APPLICATION NO.	FILING DATE	FIRST NAMED INVENTOR	ATTORNEY DOCKET NO.	CONFIRMATION NO.
10/709,886	06/03/2004	John Charles Intile	146585-1	3885
23413	7590	07/26/2005	EXAMINER	
CANTOR COLBURN, LLP 55 GRIFFIN ROAD SOUTH BLOOMFIELD, CT 06002			RODRIGUEZ, WILLIAM H	
			ART UNIT	PAPER NUMBER
			3746

Office Action Summary

DETAILED ACTION

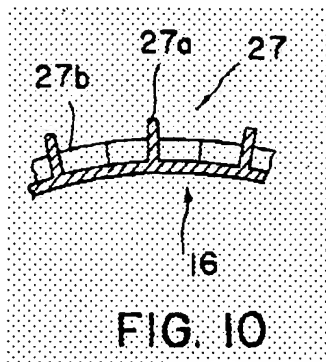
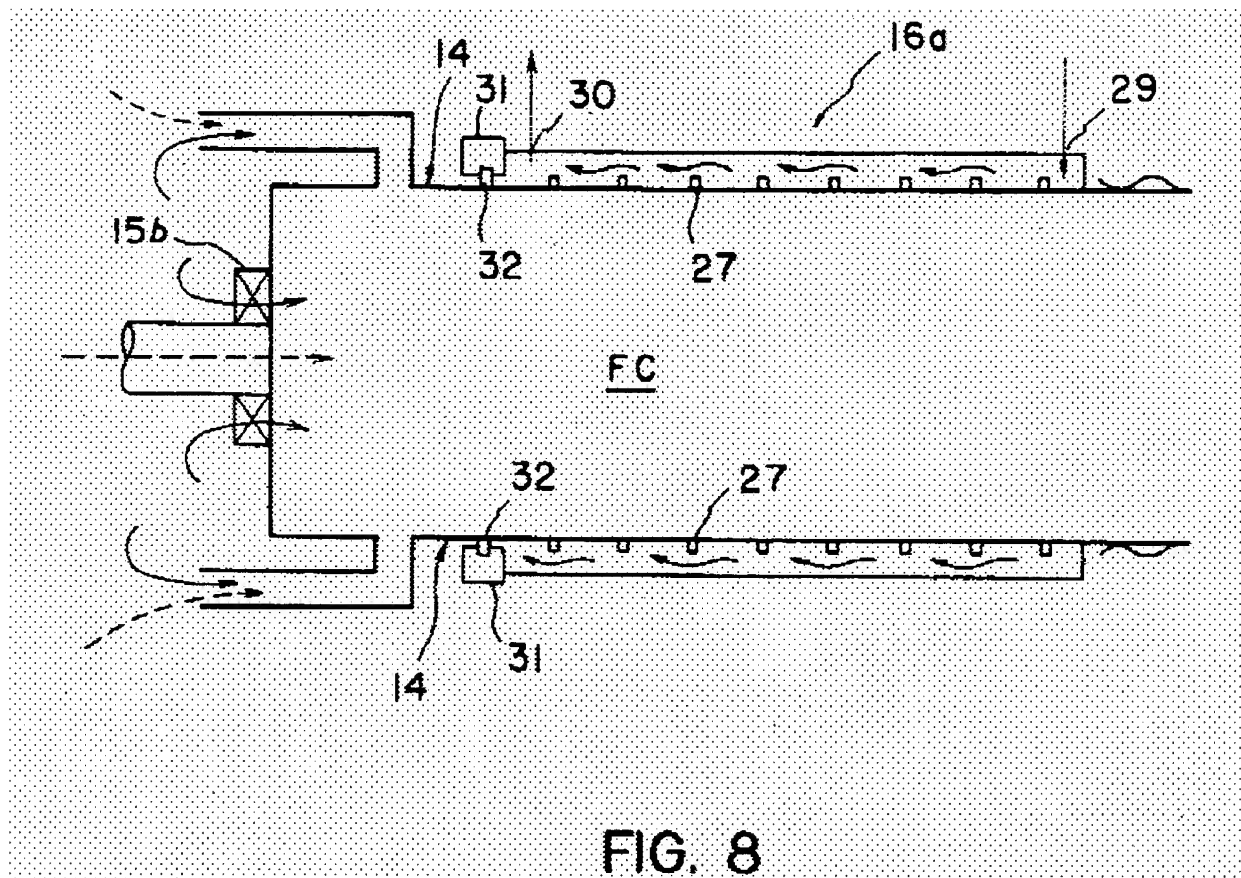
Davis teaches a combustor liner of a gas turbine combustor, said combustor liner having a substantially circular cross-section, and a first flow sleeve 26 surrounding said liner in substantially concentric relationship therewith creating a first flow annulus therebetween for

feeding air to the gas turbine combustor, and wherein a transition piece 18 is connected to said combustor liner, with the transition piece surrounded by a second flow sleeve 66, thereby creating a second flow annulus in communication with said first flow annulus, a plurality of axially spaced rows of cooling holes (70', 70) in said flow sleeves, each row extending circumferentially around said flow sleeves, a first of said rows 70 in said second sleeve 66 is located proximate an end where said first flow sleeve 26 and said second flow sleeve 66 interface, wherein cooling air is supplied to said cooling holes (70, 70'). Since **Davis** has the same structure as claimed, it is inherent that **Davis's** device would be able to perform the recited method steps. See particularly **Figure 3a** of **Davis** above.

Figures 8 & 10 of Maeda

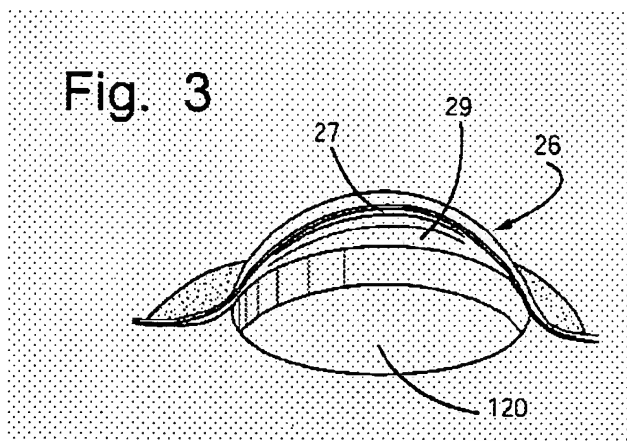
Davis does not teach a plurality of discrete ring turbulators arranged in spaced relationship on said outer surface of said combustor liner. However, Maeda teaches a combustor liner having plurality of discrete ring turbulators 27 arranged in spaced relationship on said outer surface of said combustor liner, wherein said turbulators serve to disrupt the flow on the liner surface in a manner that enhances heat transfer, thus improving the cooling performance of the combustor liner and increasing its operating life (column 9 lines 45-59 of Maeda). Therefore, it would have been obvious to one of ordinary skill in the art at the time the invention was made to have provided Davis combustion liner with Maeda's turbulators in order

to effectively cool the combustor liner by enhancing heat extraction through disruption of the flow on the liner surface and increase its operating life. See particularly **Figures 8 and 10** of **Maeda**.
